Subject: UniStar Nuclear Energy, NRC Docket No. 52-016  
Response to Request for Additional Information for the  
Calvert Cliffs Nuclear Power Plant, Unit 3,  
RAI 316, Seismic System Analysis

**Response to NRC Request for Additional Information  
RAI No. 316, Question 03.07.02-67, Seismic System Analysis  
Calvert Cliffs Nuclear Power Plant, Unit 3**

**Question 03.07.02-67**

Figure 1: Quarter Model of the CBIS at CCNPP3

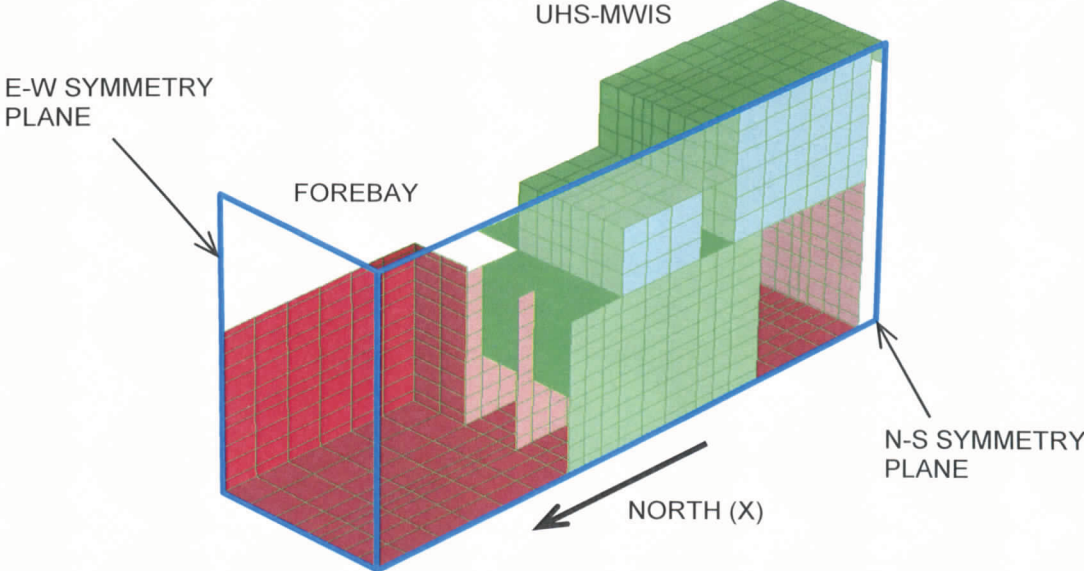
- a. Identify whether the SASSI Subtraction method is used in the seismic analyses
- b. Describe how CCNPP3 addresses the technical and software quality assurance issues raised by DNFSB letter in the versions of SASSI which CCNPP3 uses for seismic analyses
- c. If the SASSI Subtraction method is used by CCNPP3, provide an assessment to establish: 1) the seismic analyses performed in support of the CCNPP3 COL application do not contain any errors or anomalies as identified in DNFSB letter, 2) QA steps taken to ensure any future seismic analyses in support of the CCNPP3 COL application will be free from errors or anomalies as identified in DNFSB letter

A quarter model of the CBIS is created by adding two symmetric planes along the X (NS) and Y (E-W) directions (Figure 1). The results of this analysis are compared with the same structure analyzed with the Subtraction Method at several locations. The "interaction nodes" considered in the Flexible Volume Method or "direct method" model are all nodes belonging to the excavated soil volume. On the other hand, the interaction nodes considered in the Substructure Subtraction Method model are those located at the outer perimeter boundary of the excavated
